# PERMIT

## ON-SITE SEWAGE DISPOSAL SYSTEM HOWARD COUNTY HEALTH DEPARTMENT BUREAU OF ENVIRONMENTAL HEALTH

SUBDIVISION: Chessie Crossing LOT NUMBER: 23

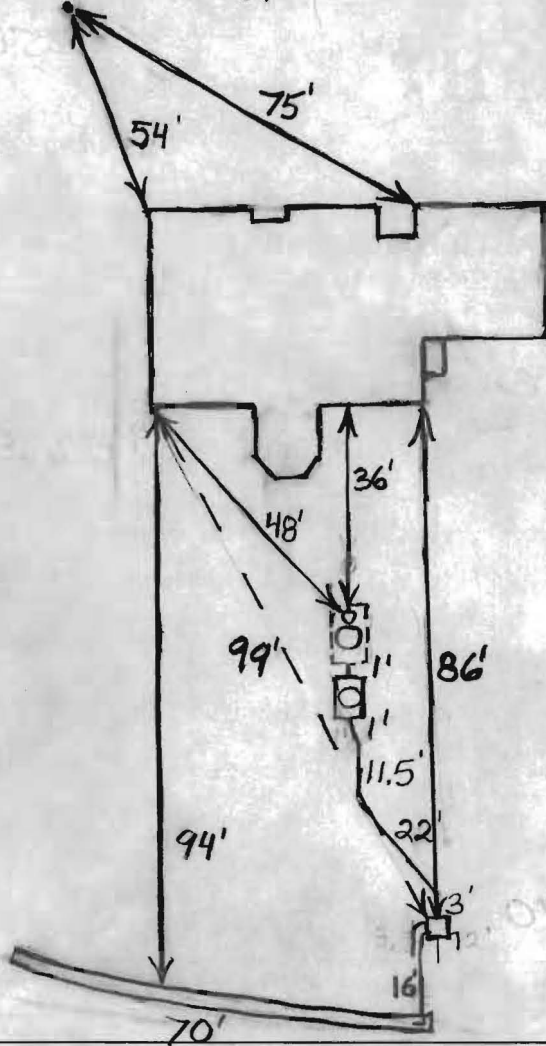
INSTALLATION 1/3/07 Clay down to close to 5'. Changed inlet to 4' and bottom to 6'. New distribution box installed and sub standard pipe from tank to distribution box replaced. O.K. to backfill. (BB)

RESIDENTIAL SITE PLAN

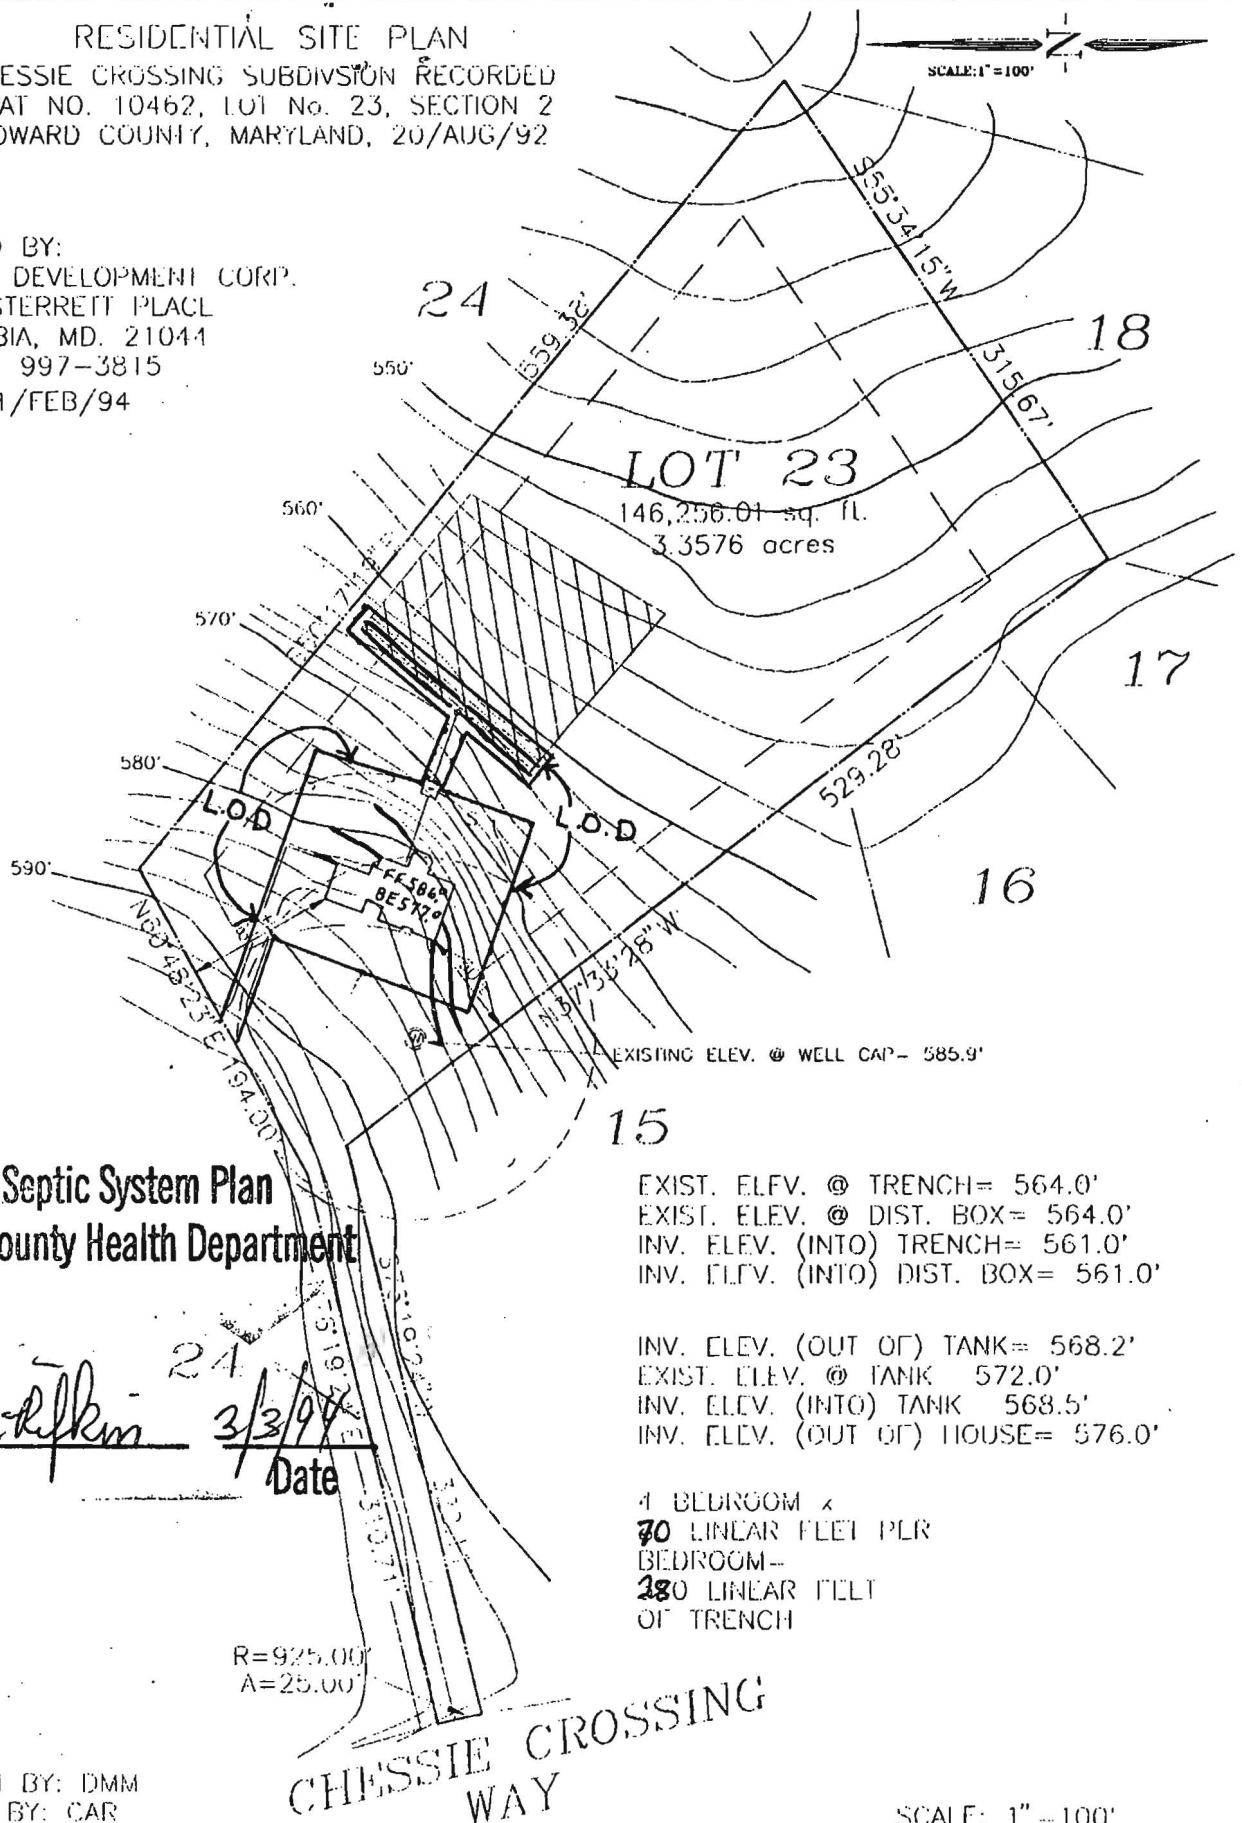
TRENCHES:	Trench to be 3.0 feet wide. Inlet 3.0 feet below original grade. Bottom maximum depth 5.0 feet below original grade. Effective area begins at 3.0 feet below original grade. 2.0 feet of stone below distribution pipe.
LOCATION:	Install trench on contour directly below one of the existing trenches. Trench placement should conserve repair area as much as possible.
NOTES:	Install a new 1500 gallon two compartment tank or add a 500 gallon tank after the existing septic tank.
